## RESPONSE TO AUDIT ISSUES

### APR1400 Topical Reports

Review Section	TR Realistic Evaluation Methodology for LBLOCA of the APR1400
Application Section	Topical Report: APR1400-F-A-TR-12004 Realistic Evaluation Methodology for Large-Break LOCA of the APR1400
Issue Date	08/13/2015

### **Audit Issues No. 27-d**

Figure 1. Mass Flow Rate at Hot Channel Exit – Original Calculation

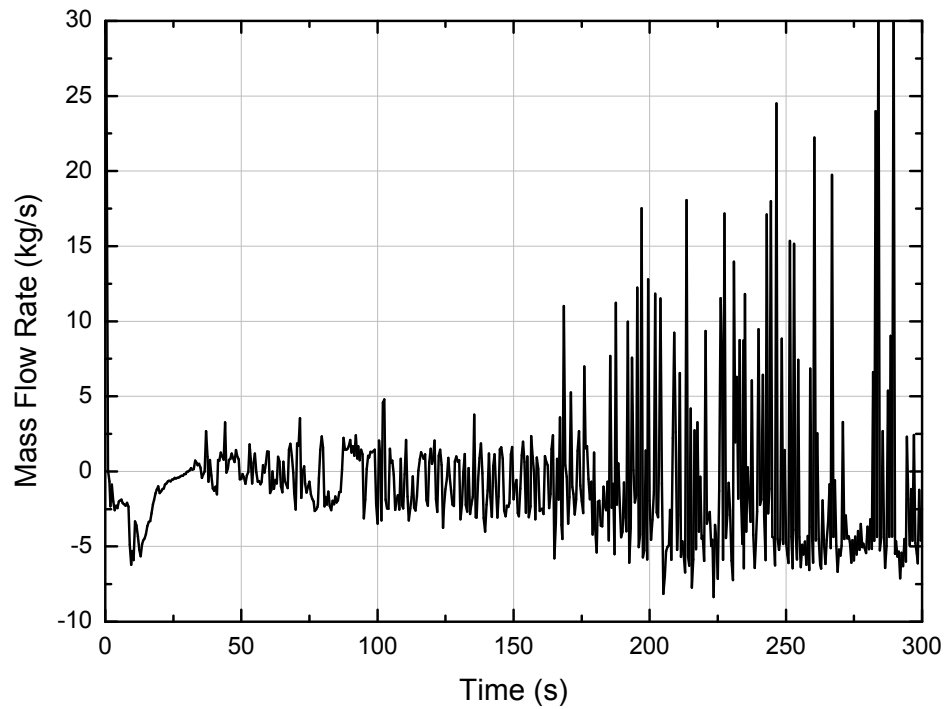
] <sup>TS</sup> The lower power peripheral fuel assemblies are also not represented separately. It is unclear how this nodalization was selected over other options and how it can model multidimensional phenomena (e.g., "upper plenum to core counter-current flows (CCF)" in topical report Table 3-2). Provide the basis for the selected nodalization with respect to capturing the multidimensional phenomena occurring in the core.

Figure 1 shows the mass flow rate at the hot channel exit and it can be seen that some down flow occurs during reflood period. In order to confirm the effect of the down flow, sensitivity calculation was performed by limiting the down flow. For the limitation of the down flow, the reverse K-factor of the junction connecting the hot channel exit and upper plenum was assumed to be very large value. Figure 2 through 4 compare the mass flow rate at the core exit, heat transfer mode and cladding surface temperature at the PCT node respectively. During the reflood period, the heat transfer mode is film boiling until core quench. During film boiling period, heat transfer between wall and liquid is very low because the liquid does not contact directly to the wall. Therefore, even though there is some down flow at the upper region of the hot channel, it does not affect the cladding temperature as shown in Figure 4.
